DOCUMENT CHANGE REQUEST

DCR number 253	Changes required for: General	Originator: S JEFFERY
Date: 2006/04/04	Date sent: 2006/04/04	Organisation:
Status: IMPLEMENTED

Title:	Transistors Low Power PNP, based on type 2N5401		
Number:	5202/014	Issue:	1

ESCC Detail Specification No. 5202/014

1.6.1 Metal Can Package (TO-18) - 3 lead

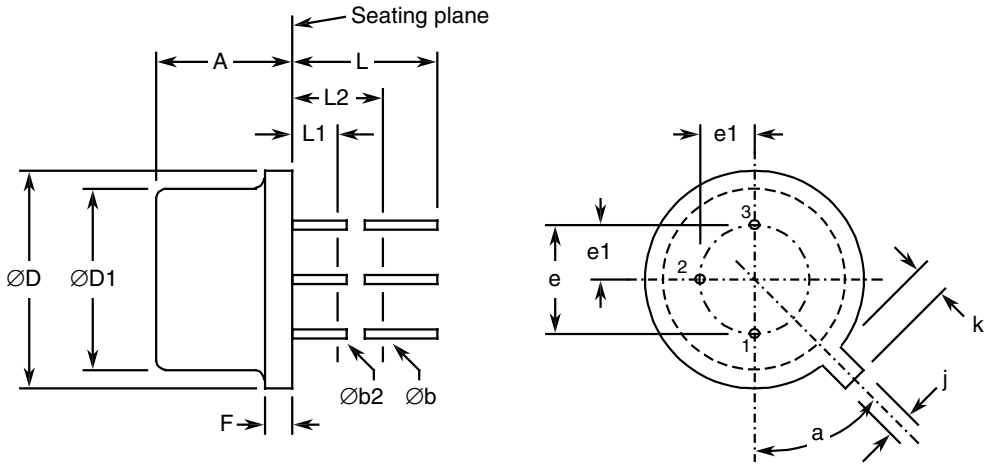
8. Figure 2 re-named .Physical Dimensions and Terminal Identification.; Figure 2(a) amended to reflect the TO-18 package currently supplied. Notes revised, including addition of a terminal identification note.

9. Para. 4.4.1 Case requirements for Variants 01 and 02 corrected to reflect a TO-18 metal can.
10. Para. 4.4.2 Lead Material and Finish replaced by a reference to the Component Type Variants Para.

1.7 FUNCTIONAL DIAGRAM

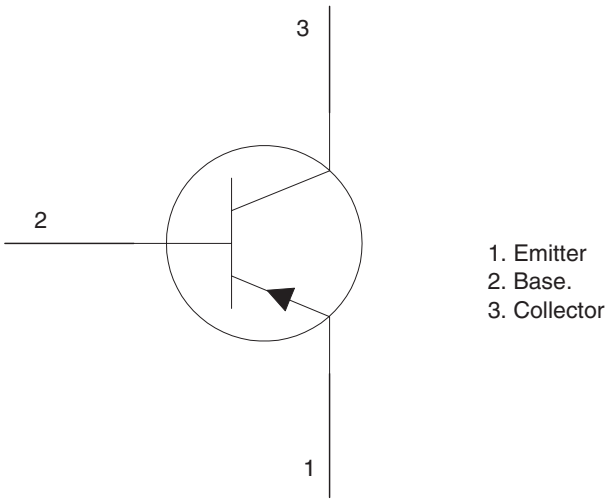
11. Delete requirement for marking of the test level letter from ESCC component number as per latest ESCC No. 21700.
12. Figure 3 (Functional Diagram): Note added to clarify that the lids of the CCP packaged devices are not connected to

any terminal.
13. Table 2, Characteristic .D.C. Forward Current Transfer Ratio. has been changed to .Forward-Current Transfer Ratio..
14. Table 2, Characteristic .A.C. Forward Current Transfer Ratio. has been changed to .Small-Signal Current Gain..

NOTES:
1. For TO-18, the collector is internally connected to the case.
2. For CCP the lid is not connected to any terminal
